Revised Nevada Division of Environmental Protection BART Determination Review of NV Energy's Reid Gardner Generating Station Units 1, 2 and 3

FIGURE 1
LEAST COST ENVELOPE

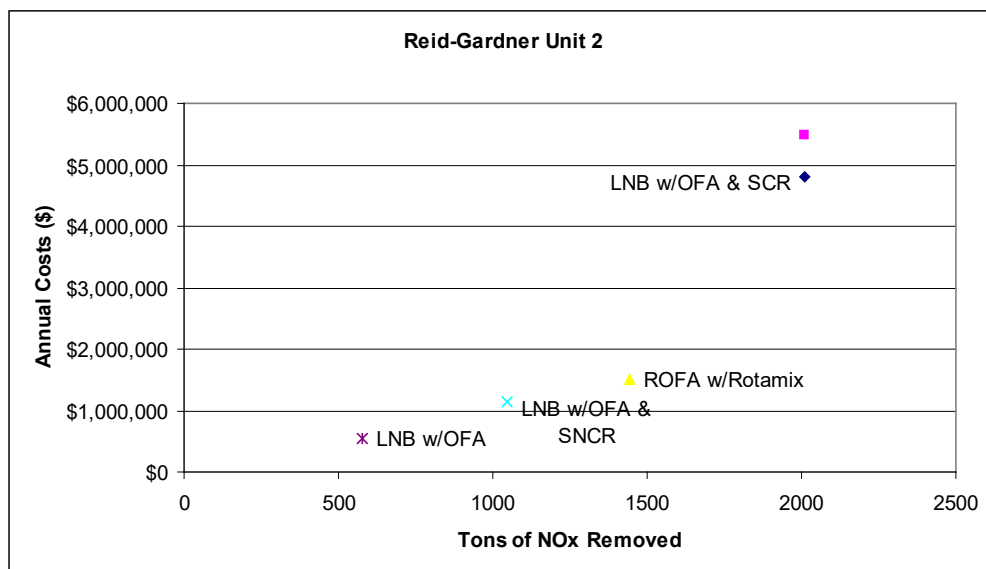
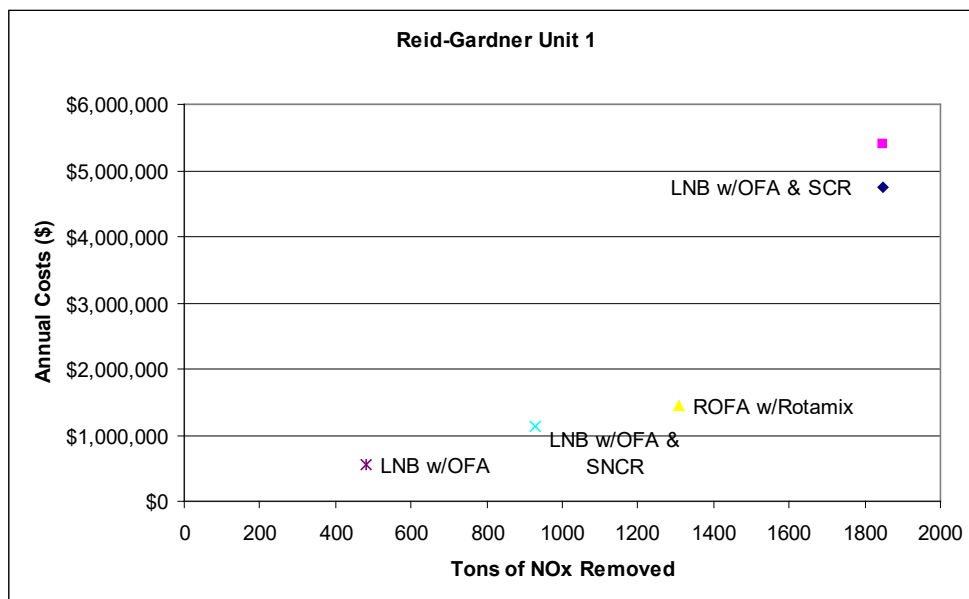
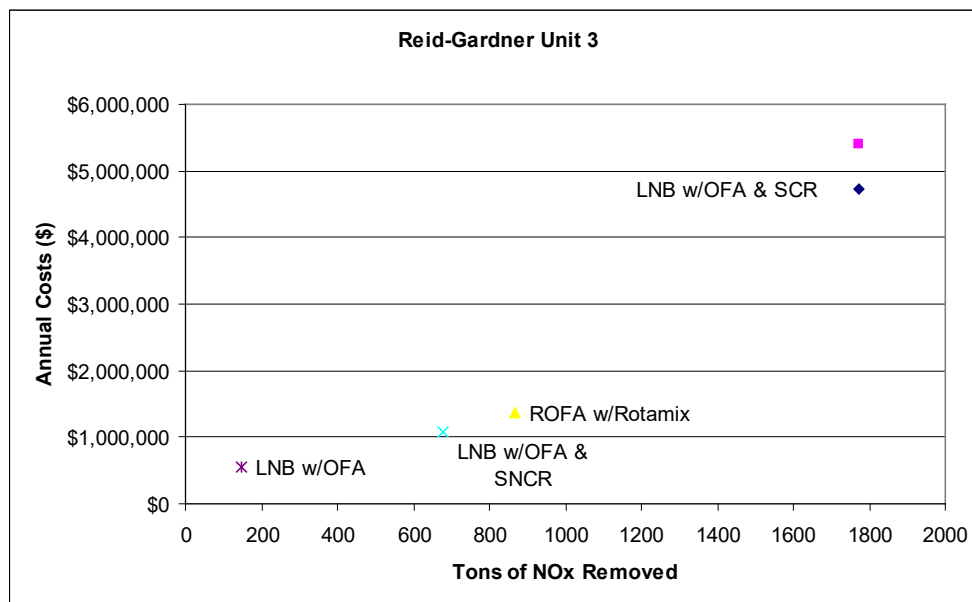
NDEP specifically reviewed the cost per ton of NO_x removed for each unit at Reid Gardner and determined that installation of ROFA with Rotamix for units 1 through 3 is BART for NO_x, with associated first year costs of \$1,038 to \$1,588/ton of NO_x removed, depending on the unit evaluated. These values are considered cost effective. The cost data from the tables above are presented graphically in Figure 1. NDEP also considered the Clean Air Act factors of expected emission rates, emissions performance levels, expected emissions reductions, energy impacts, non-air quality environmental impacts and modeled visibility impacts in Nevada's control technology determination. NDEP concluded, based on a review of the economic analysis, that the \$/ton of NO_x removed increased significantly for the LNB with OFA and SNCR, and ROFA with SCR technologies without correspondingly significant improvements in visibility.

NDEP concludes that for NO_x the installation of ROFA with Rotamix with an emission level at 0.20 lb/MMBtu for unit 1 and unit 2, and 0.28 lb/MMBtu for unit 3, on a 12-month rolling average, is BART. NDEP concludes that BART for SO₂ is the existing wet soda ash FGD with emission limits of 0.15 lb/MMBtu, 24-hour average, for all three units and BART for PM₁₀ is fabric filter with emission limits of 0.015 lb/MMBtu, 3-hour average, for all three units.
